From: Anna Tidey
Sent: 01 June 2026 11:43:12 UTC+01:00
To: "Buchan Rum Architects" <info@buchanrumarchitects.co.uk>
Cc: "Emma Buchan" <emma@buchanrumarchitects.co.uk>; "Emily Hatton" <emily@buchanrumarchitects.co.uk>
Subject: Request for EOT/ Amended Plans DM/26/0561 - variation of condition - 35 BLUNTS WOOD ROAD HAYWARDS HEATH WEST SUSSEX RH16 1ND
Attachments: DSCF0765.JPG, DSCF0766.JPG, DSCF0767.JPG

Subject: FW: Photos from Site visit for DM/26/0561 - variation of condition - 35 BLUNTS WOOD ROAD HAYWARDS HEATH WEST SUSSEX RH16 1ND

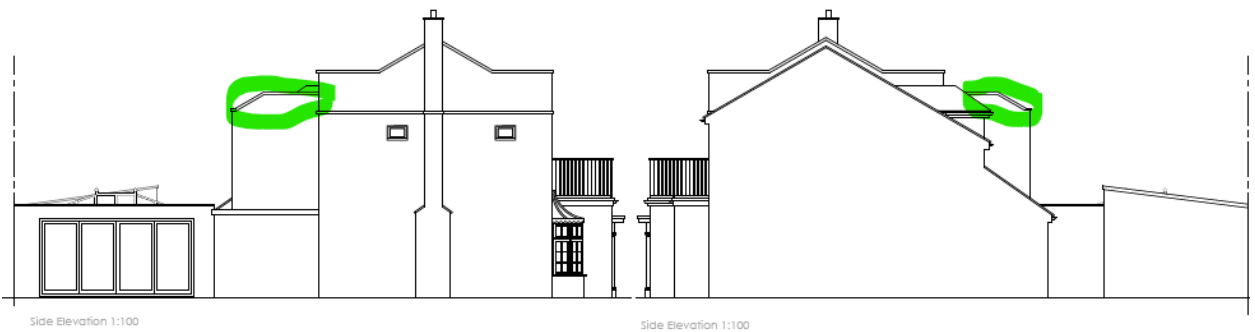
As discussed earlier today, please see attached the photos I took at the site on 07.05.2026. Unfortunately the presence of the scaffolding makes it difficult to see the building work that has progressed clearly, but at the highlighted points on the plan extract below the works in progress vary from the details shown on the submitted plan Proposed Elevations 24_223_PL_112 Rev 03. I appreciate that you may need to visit the site yourselves to see the variations, which include:

Crown roof form to the first floor addition

Differing cill heights on first floor windows

Enlarged ground floor opening for reuse of existing 4 panelled bifold doors

Please can Amended Plans be submitted to correspond with the works that are substantially underway on the site?
Please can you also agree an extension of time for the decision target date to allow for the receipt and readvertisement of these Amended Plans?
